Statement to the NRC Atomic Safety and Licensing Board

Re: Contentions 3,6 and 9

Dewey-Burdock Project

Central Processing Plant

Figure 5.3-4

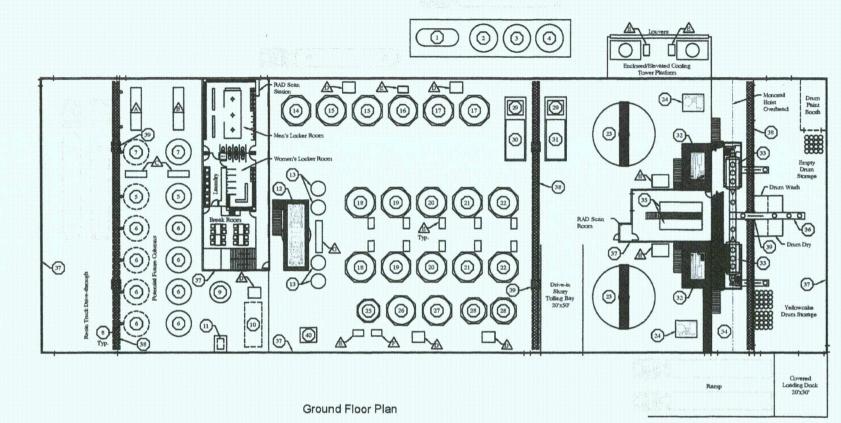
This is the diagram of the Dewey-Burdock Project's Central Processing Plant, showing storage of the various chemicals to be used. In Powertech's September 2012 application narrative, nine chemicals are specifically named. Barium Chloride, #40, is stored <u>here</u>. Stored <u>outside</u> will be Sulfuric Acid and/or Hydrochloric Acid, Hydrogen Peroxide, and Sodium Hydroxide. Sodium Hydroxide, which is #2, will be stored <u>here</u>, as precisely indicated in the Key Notes. <u>Close transparency.</u>

Here's a closer look at the Key Notes. #2 is clearly the symbol in English for Sodium Hydroxide. What are the 22 additional unduplicated chemicals listed in the Key Notes? None of these chemicals are labeled with standard English formulas; though 1, 3, and 4, to my unpracticed eye, look part-Chinese. Not listed in the Key Notes are seven chemicals that are named and described in the application, although they may be on the Key Notes list with non-English labels. What precisely are these 22 chemicals?

When I looked at #9 and saw the word "gulp", I did just that---- It's alarming to see so many mysteriously labeled chemicals with no explanation from the mining company.
